Circular No. 195 / 2023

Field Safety Notice of Giraffe OmniBed and Giraffe OmniBed Carestation from GE Healthcare.

GE HealthCare Ref. # 32089

RE: **Giraffe OmniBed and Giraffe OmniBed Carestation potential incorrect secondary latch installed on certain bedside panels.**

Figure 1. Bedside Panels showing Northeast (NE) and Northwest (NW) latches

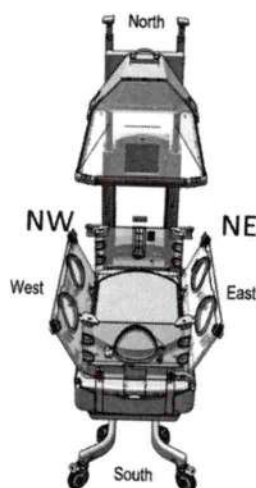
GE HealthCare has become aware of the potential that an incorrect type of secondary latch could have been installed on the northeast (NE) and/or northwest (NW) bedside panels for certain Giraffe OmniBed and Giraffe OmniBed Carestation devices (see figure 1).

The secondary latch mechanism serves two functions: (1) acts as a "catch" and reduces the potential for the bedside panel to fall if the user does not latch the primary latch mechanism correctly and (2) keeps the north wall in place when the canopy is raised.

For devices that have the incorrect type of secondary latch installed, the north wall can potentially become disengaged when the canopy is raised. However, the device

is designed such that the panels will stay closed and function as intended, even if only the primary latches on the south end are properly engaged.

Inspect the device bedside panels as instructed in **Appendix A**. If the device has the correct latches, continue to use the device. If the device does not have the correct latches, follow the instructions in Appendix A prior to clinical use.

GE HealthCare will replace all affected latches at no cost to you.
A GE HealthCare representative will contact you to arrange for replacing any incorrect latches.
8004292222 SaudiArabiaServiceCenter@ge.com

Figure 2. North end bedside panel latch locations

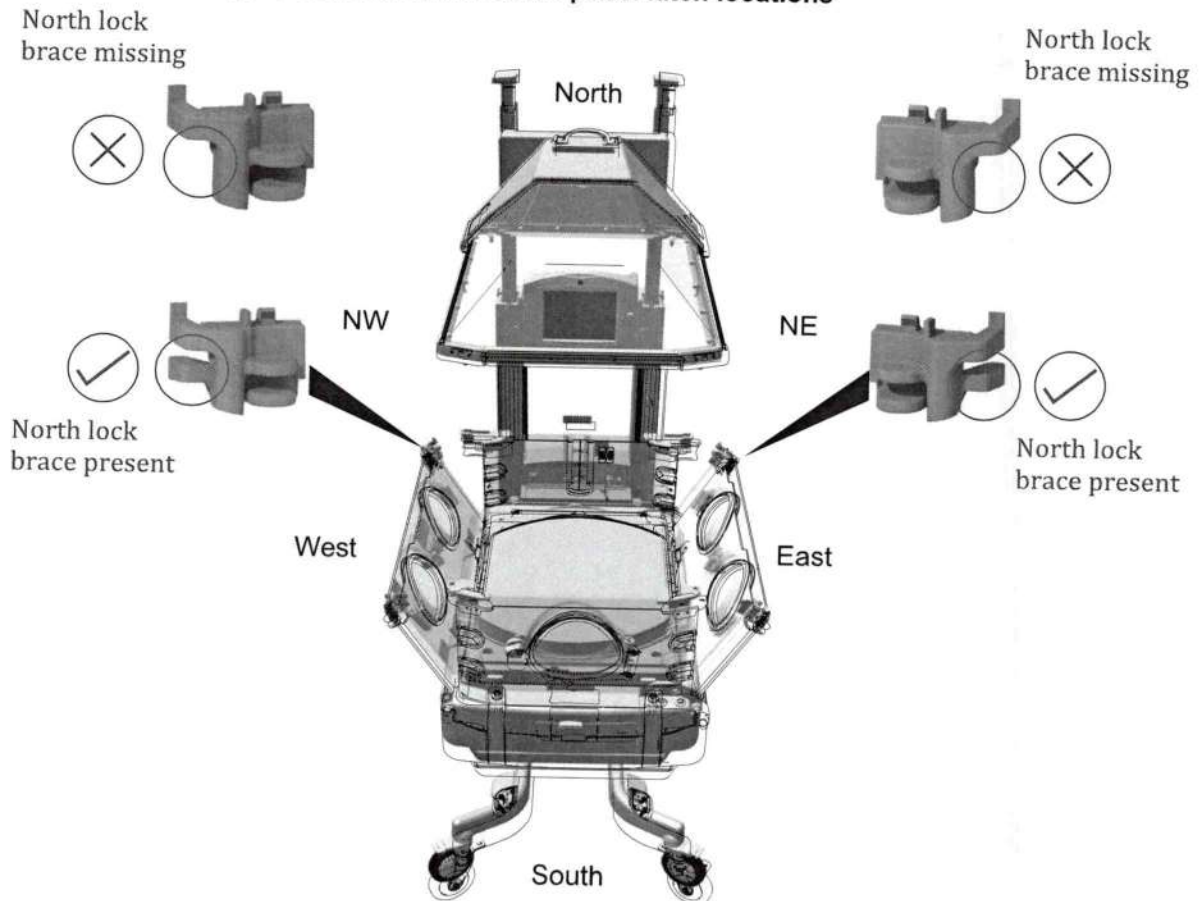
1. Visually inspect the NW and NE bedside panel latch assemblies on all Giraffe OmniBeds and Giraffe OmniBed Carestations to ensure the correct latches are present (See Figure 2).

2. If an incorrect latch is found quarantine the device.
3. Inspect any field replaceable bedside panel stock at your facility per Figure 2 for the parts #'s listed below to ensure the correct latches are present and quarantine any field replaceable bedside panels with incorrect latches.
 - 5865384-01 to 5865384-34,
 - 5865385-01 to 5865385-34,
 - 5865386-01 to 5865386-34 and
 - 5865387-01 to 5865387-34
4. Record the results of the inspections on the provided Medical Device Notification Acknowledgement Response Form and send this form to GE HealthCare at MIC.FMI32089@ge.com
5. GE HealthCare will contact you to arrange for shipment of replacement latches. These will be provided free of charge to you.
6. Once correct latches are received, replace the incorrect latches with the correct latches and dispose of the incorrect latches.
